**ADDENDUM NUMBER ONE (1)
TO THE PLANS AND SPECIFICATIONS FOR:**

July 24, 2026

**Harmony Public Schools
Harmony Science Academy
City Place Phase 2
New High School / Middle School
22000 Springwood Village Pkwy.
Spring, Texas 77077
Project No. 24.23**

**GIGNAC & ASSOCIATES
416 STARR STREET
CORPUS CHRISTI, TEXAS 78401
(361) 884-2661**

Sheet Title:
**PLATFORM & RAMP
SECTIONS & DETAILS**

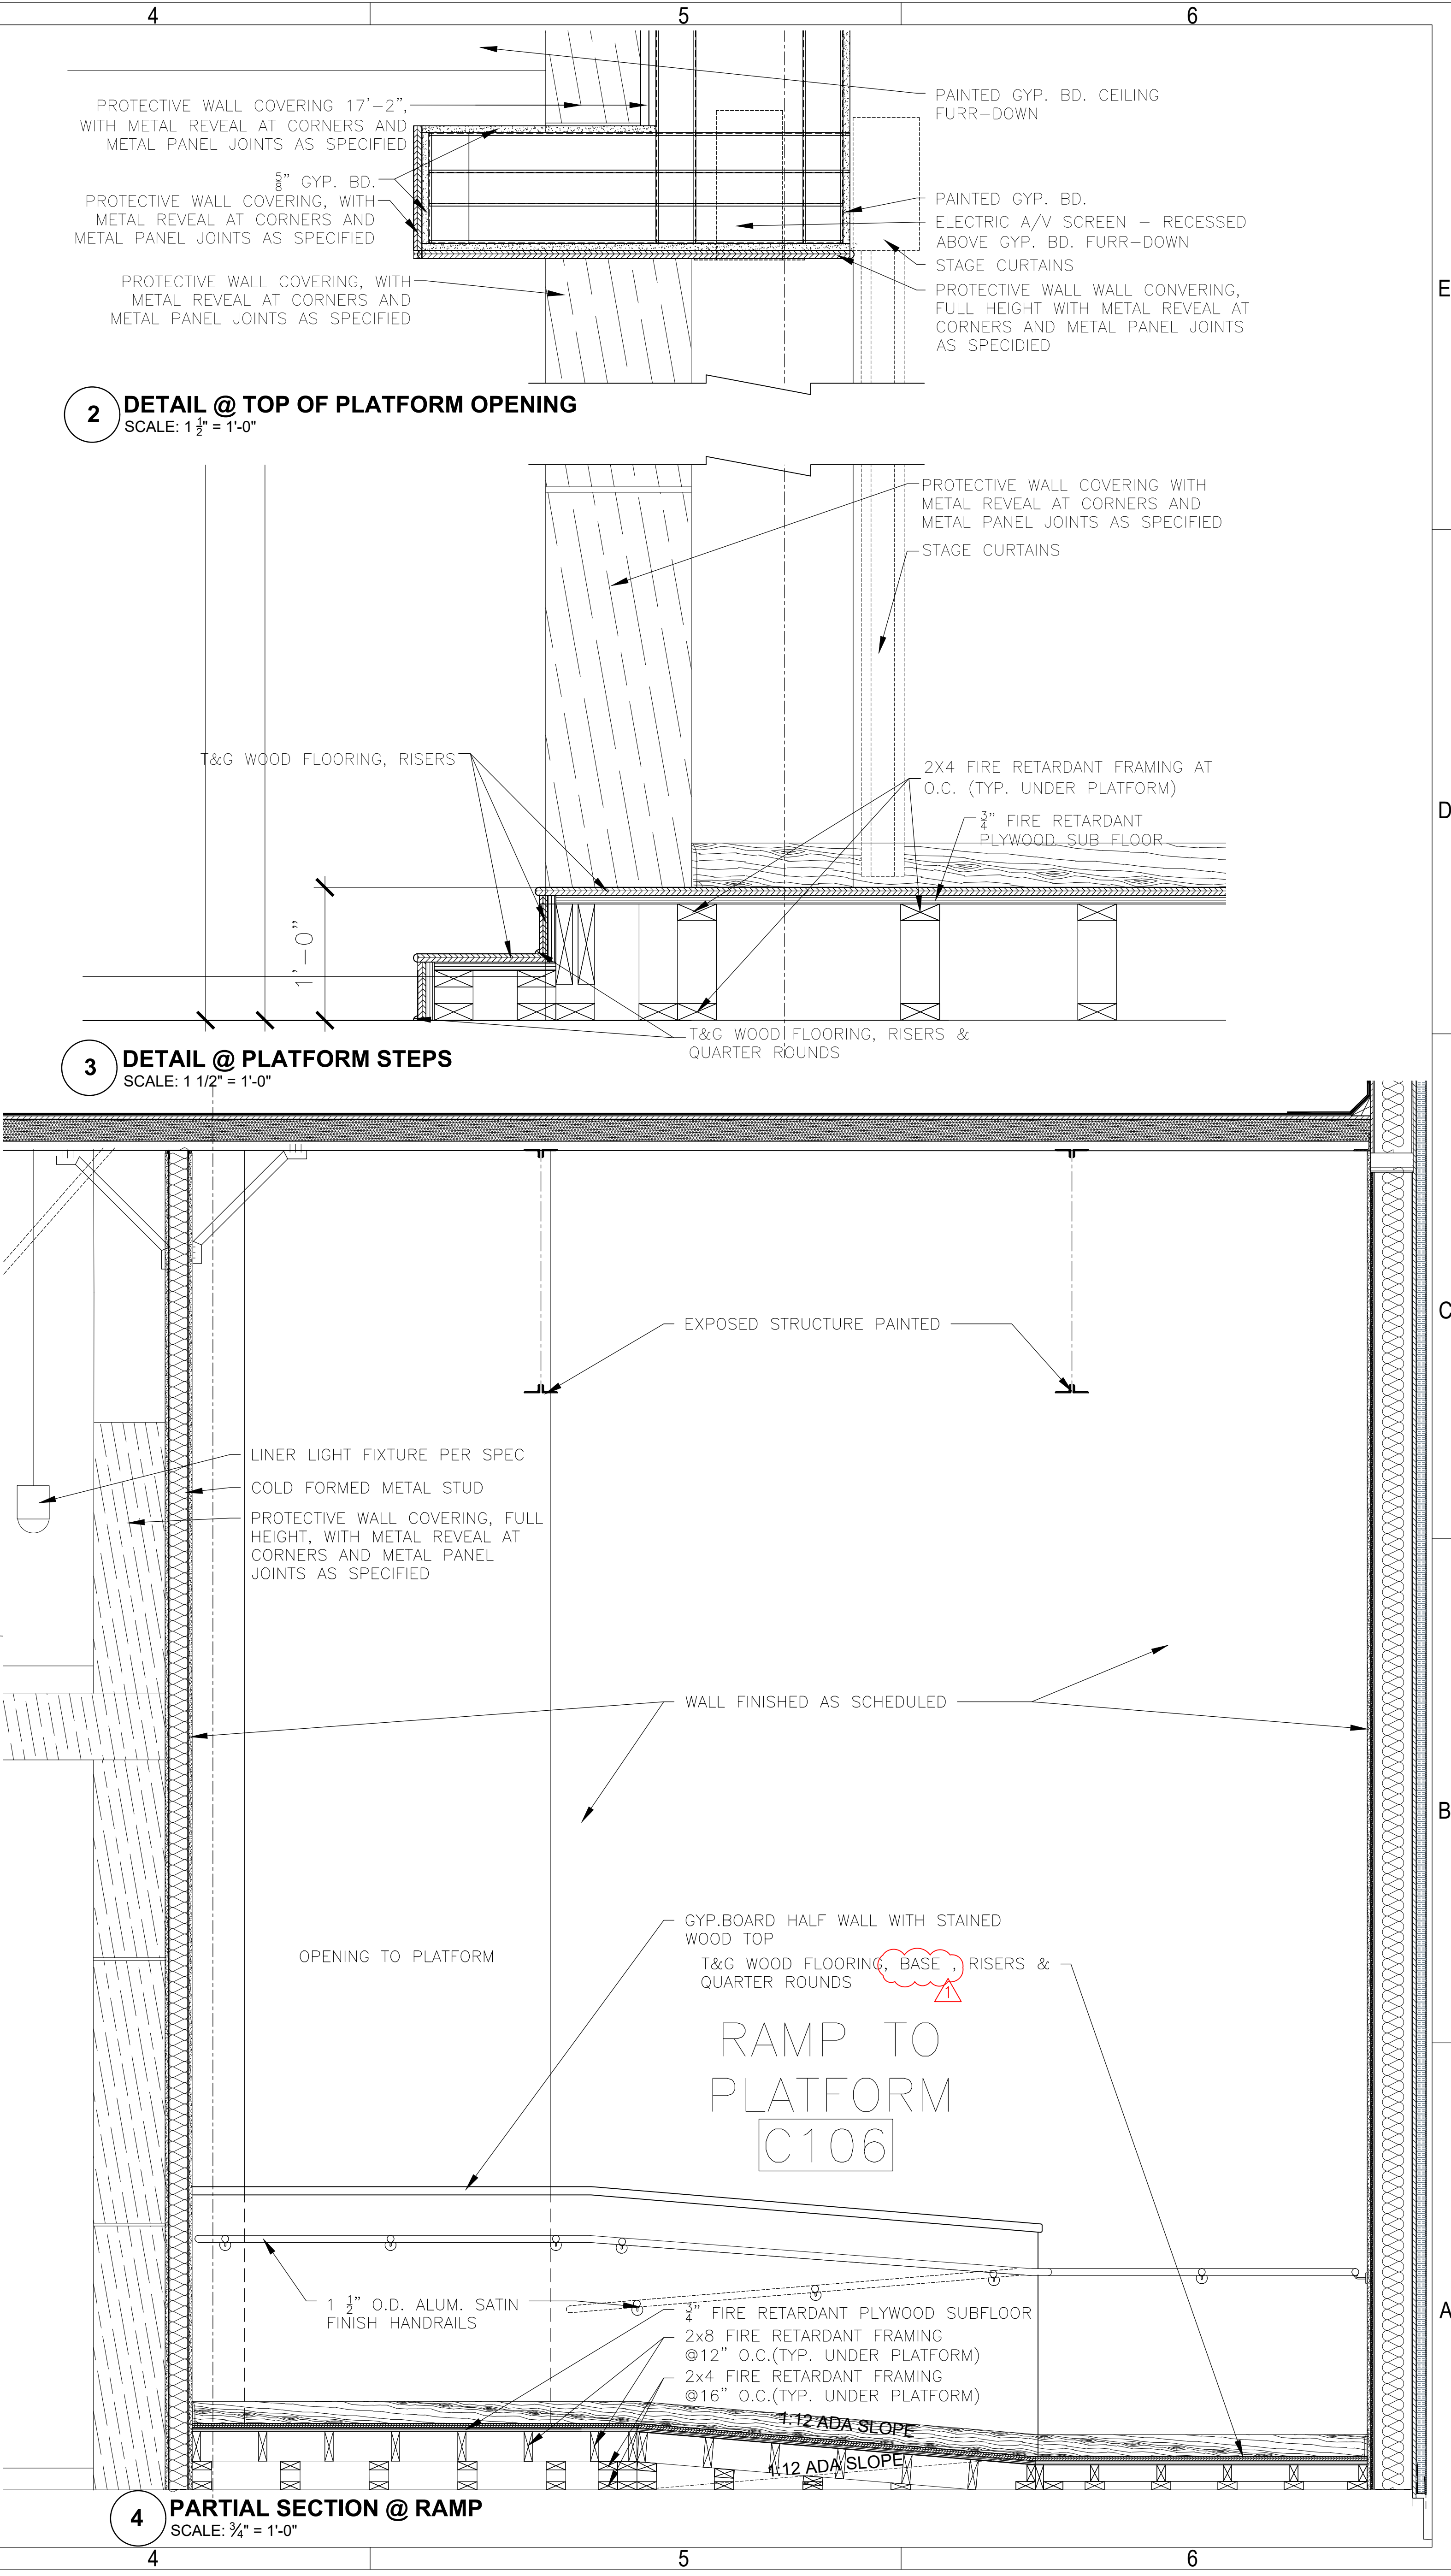
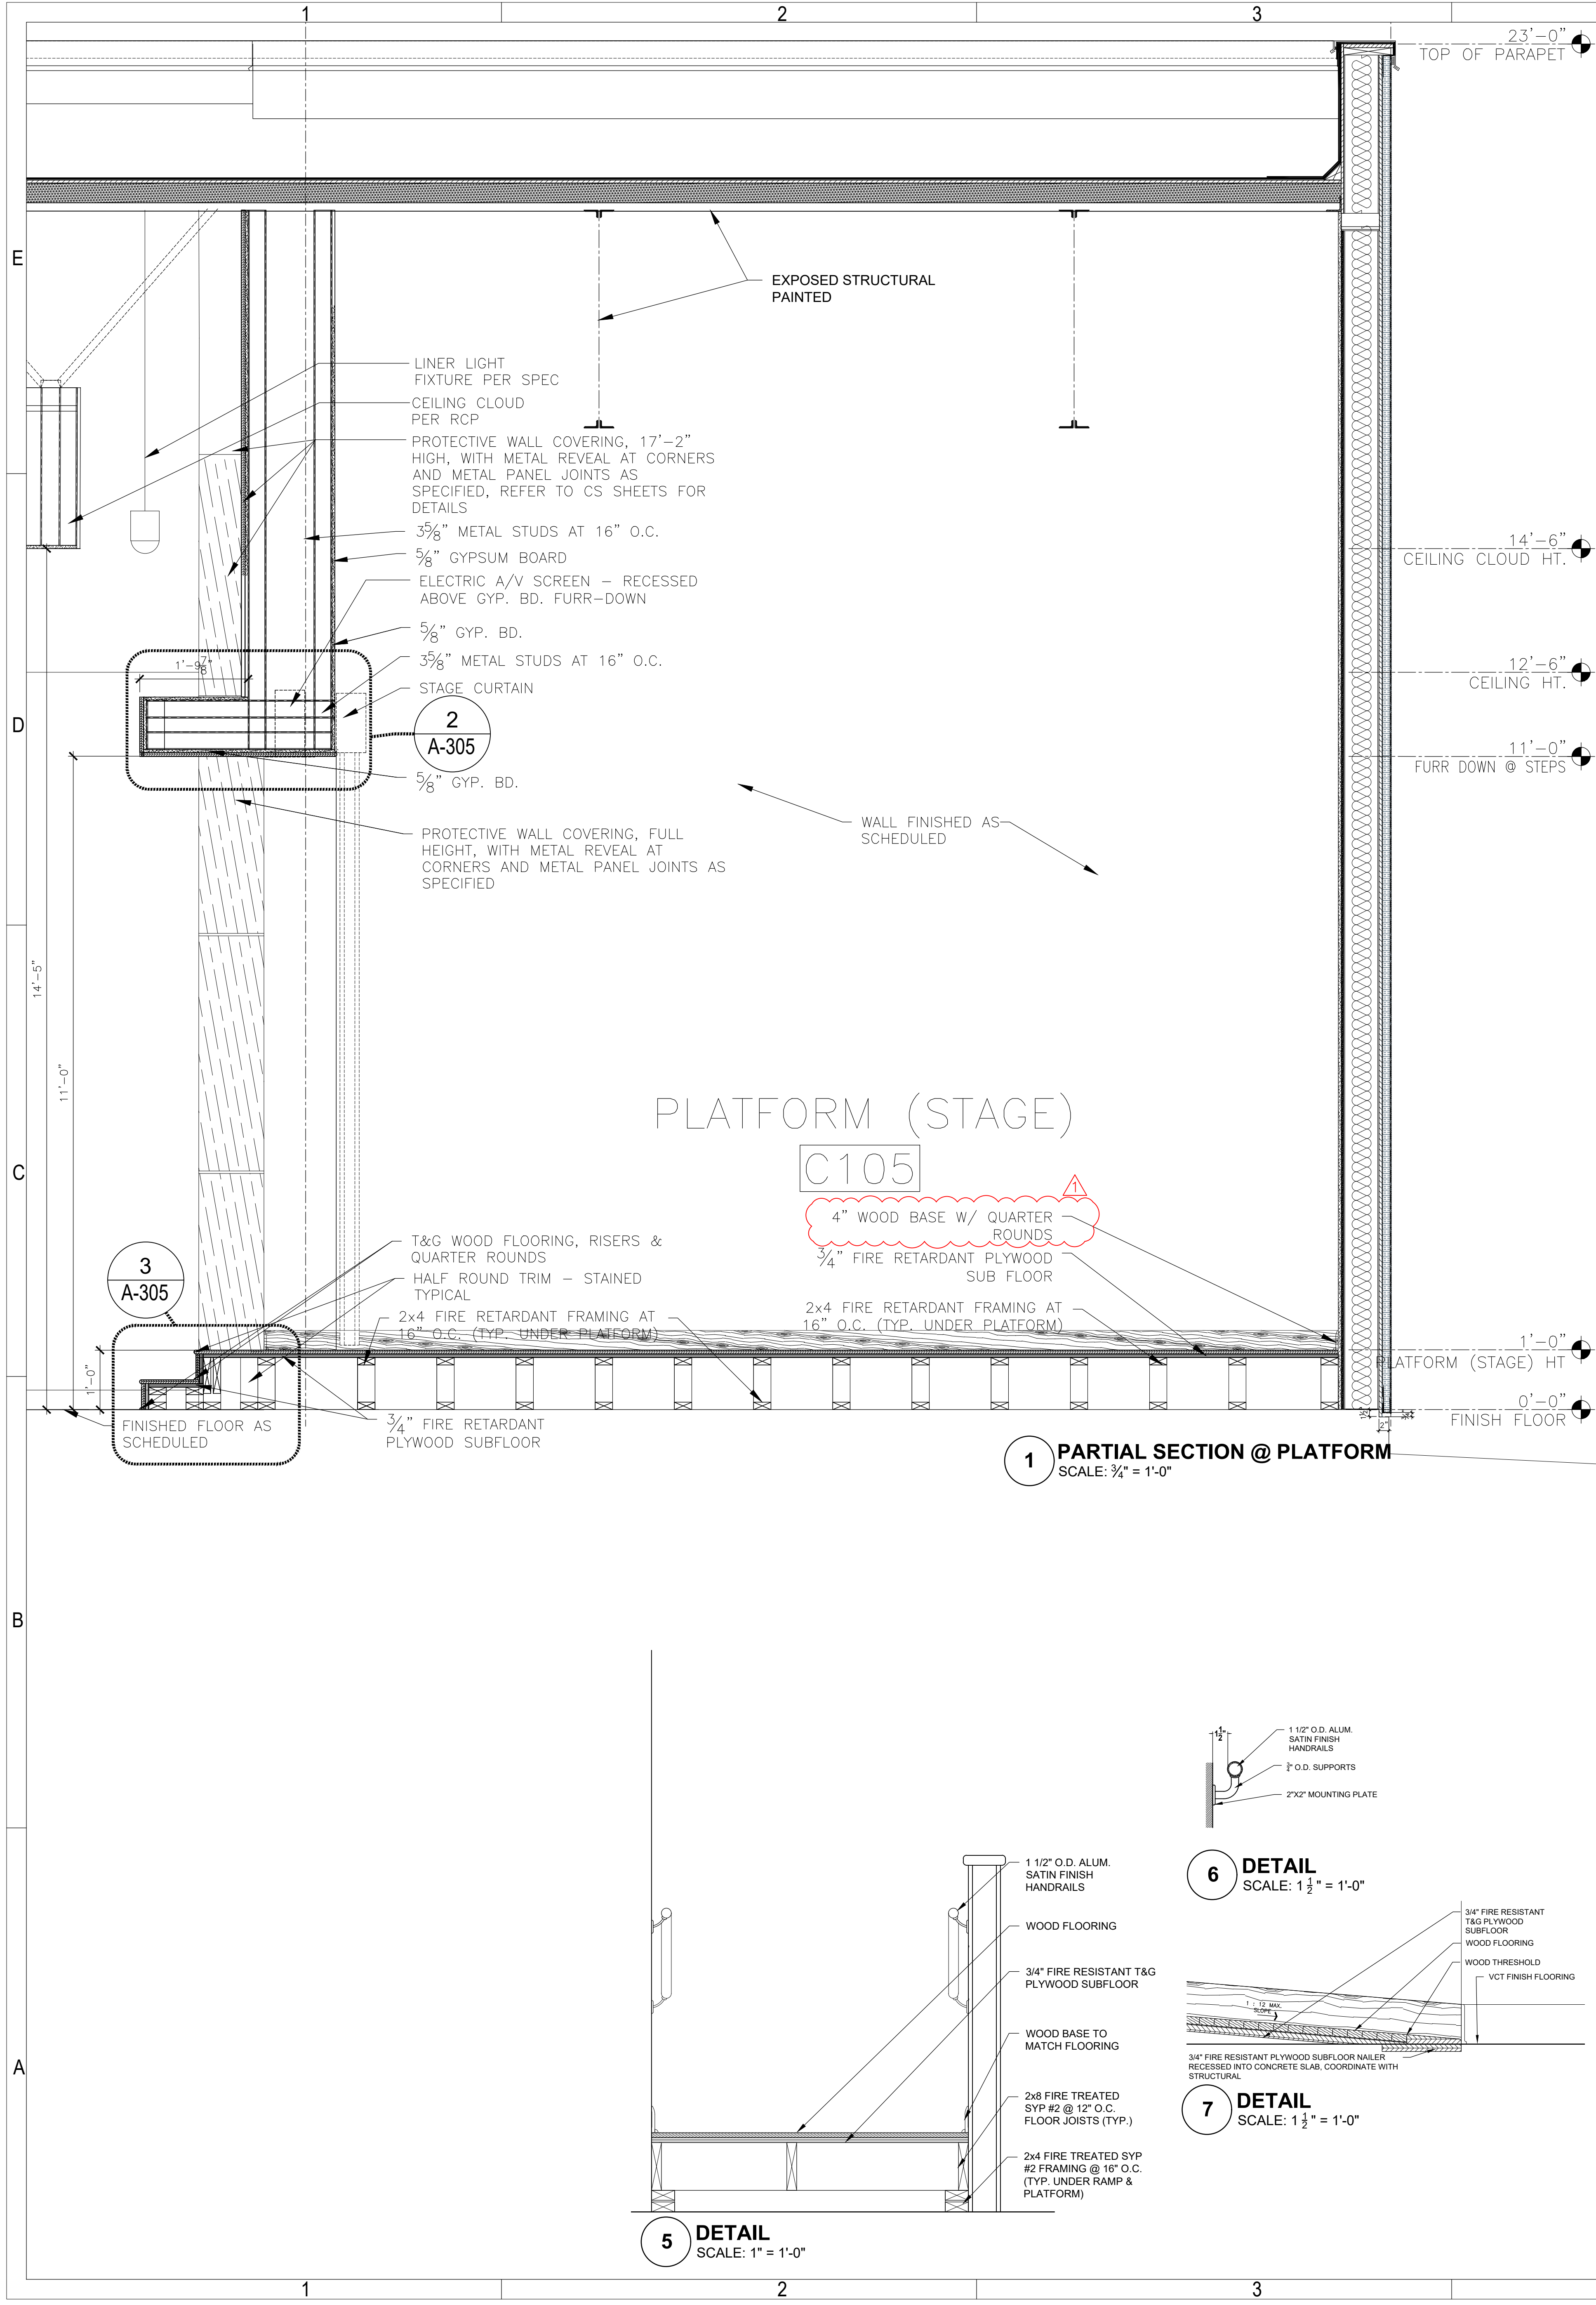
Question 22: Reference A-115 & 5/A-305. The room finish schedule calls for rubber base at the stage and ramp, but 5/A-305 calls out wood base to match flooring. Please advise what base is needed in this location.

2. Base finish updated at ramp and stage.
- Item P- 14** Sheet A-305 Platform and Ramp Sections and details
1. Delete this sheet in its entirety and replace with sheet A-305, included within this addendum.

Answer 22: Refer to revised drawings attached to this addendum.

2. Wood base finish added to stage and ramp detail.
- Item P- 15** Sheet A-401 Partial roof plans – Area A/B
1. Add missing sheet A-401, included within this addendum.
